**TOWN OF FAIRFAX
STAFF REPORT
Department of Planning and Building Services**

TO: Fairfax Planning Commission
DATE: May 19, 2016
FROM: Jim Moore, Director of Planning and Building Services
Linda Neal, Principal Planner
LOCATION: 118 Tamalpais Road; Assessor's Parcel No. 001-121-61
ZONING: Residential RS-6 Zone
PROJECT: Construction of front access stairway to residence
ACTION: Side-yard Setback Variance and Encroachment Permit;
Application # 16-20
APPLICANT: Nick Rasic
OWNER: Federal National Mortgage Association
CEQA STATUS: Categorically Exempt, § 15302 and 15305(a)

118 TAMALPAIS ROAD

GEOTECHNICAL RE-EVALUATION
AND
PLAN REVIEW & ACCEPTANCE
DRILLED I-BEAM &
TIMBER LAGGING BULKHEAD
AND WOOD STAIRWAY
CUT INTO RISING SLOPES
118 TAMALPAIS AVENUE
FAIRFAX, CALIFORNIA

GENERAL PLAN
PROPOSED DRILLED I-BEAM
RETAINING WALL
STAIRWAY ACCESS CUT
118 TAMALPAIS RD
FAIRFAX, CA
FOR AMERICAN LAND SURVEYING

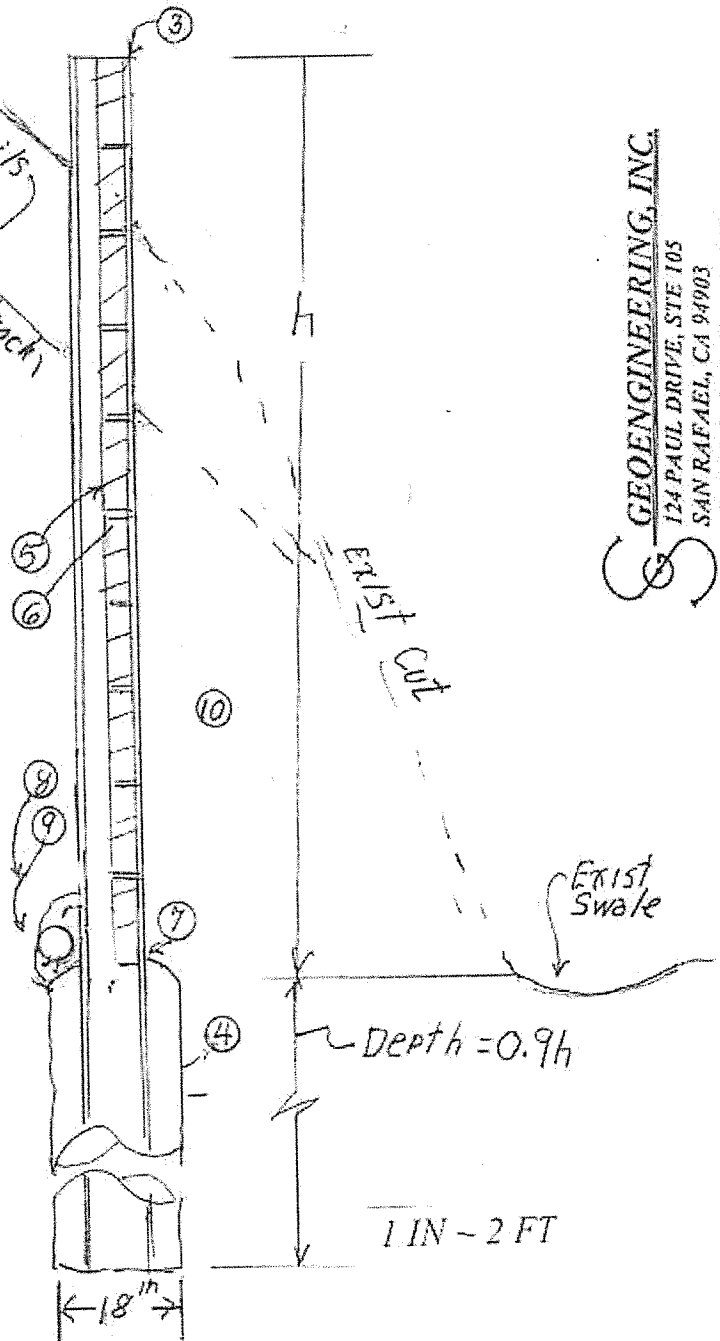
- ① Work to Be Monitored & Approved By Engineer Who Would Implement Appropriate Modifications to Suit Exposed Conditions.
- ② Sockets Drilled on ~5 Ft Centers. Positions May Be Adjusted To Facilitate Drilling.
- ③ I-beams to Be 50 Ksi Steel; W8 X 24 or Equal for H < 10Ft. W8 X 21 or Equal for H < 9 Ft. W8 X 15 or Equal for H < 8 Ft.
- ④ Concrete to Be at Least 2,500 Psi.
- ⑤ Lagging to Be 4X12 Grade 2 Doug Fir or Equal; & Approved For Earth Contact. Cuts Tot Be Treated with Preservative 3X12 Lagging May Suffice If Approved by Engr.
- ⑥ ~3/8 Inch Gaps Between Lagging.
- ⑦ Spacing below Bottom Lagging Member May Be Adjusted by Engineer
- ⑧ Class 2 Permeable Drainrock or Miridrain for Backdrainage
- ⑨ Bottom-perf Pipe May Be Deleted If Seepage at Base Is Acceptable.
- ⑩ Final Grading for Drainage to Be Developed During Construction.
